**ZONING CHANGE REVIEW SHEET  
FOR TERRACE PUD**

**CASE:** C814-86-009.12

**PROJECT NAME:** Terrace PUD (Revision 12)

Exhibit 2

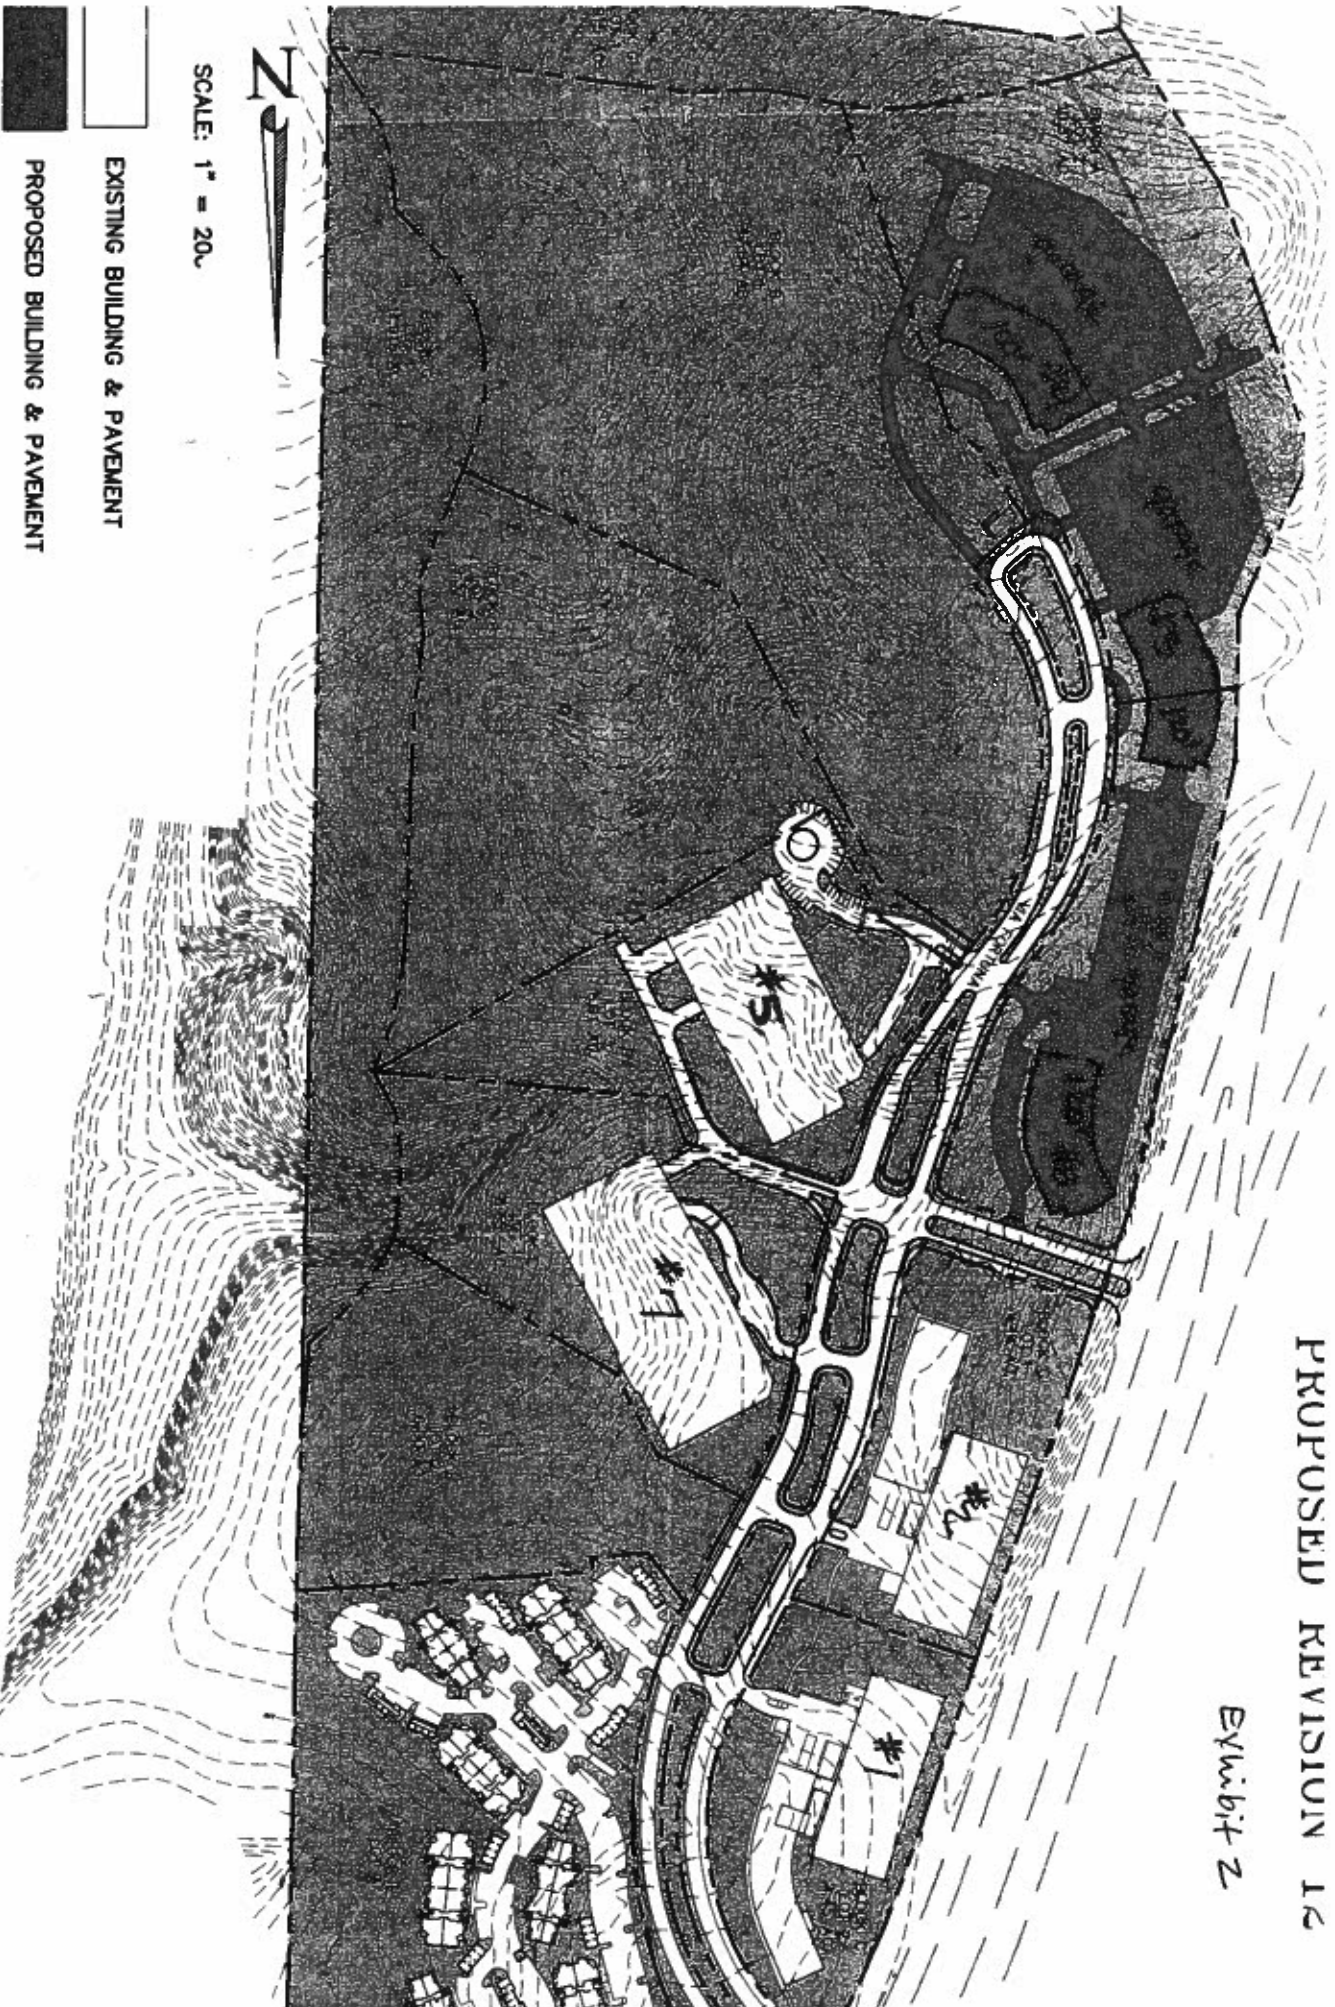
4. Water quality capture volume will be 1" for all buildings.
  5. Staff recommends the building heights for the proposed buildings 3 & 4, be switched, due to the visual impact in the Hill Country Corridor. Building 3 would be approximately 100' and building 4 (which is set back further along the slope) would be approximately 120'.
- The applicant has agreed to the conditions 1-4.

The applicant is requesting building 3 to be 120' (but would be allowed a height up to 138' for exception to heights such as parapets walls, mechanic equipments, etc.) and building 4 an absolute height of 100'. Staff is recommending the height of the proposed buildings 3 & 4 be switched to mitigate the visual impact with the Hill Country view corridor. Because of the proposed location of the building 3, which is 90' from the bluff, it is more visible from the Hill Country Roadway and its height would be exaggerated. The topography of building 3 is approximately 6 to 8 feet higher than Building 4, thus making the height difference between them approximately 45 feet (equivalent to a 3 story building). By relocating the height of building 3 to the building 4 site, the visual impact would be less intrusive from the Hill Country Roadway, which is 380' from the bluff line.
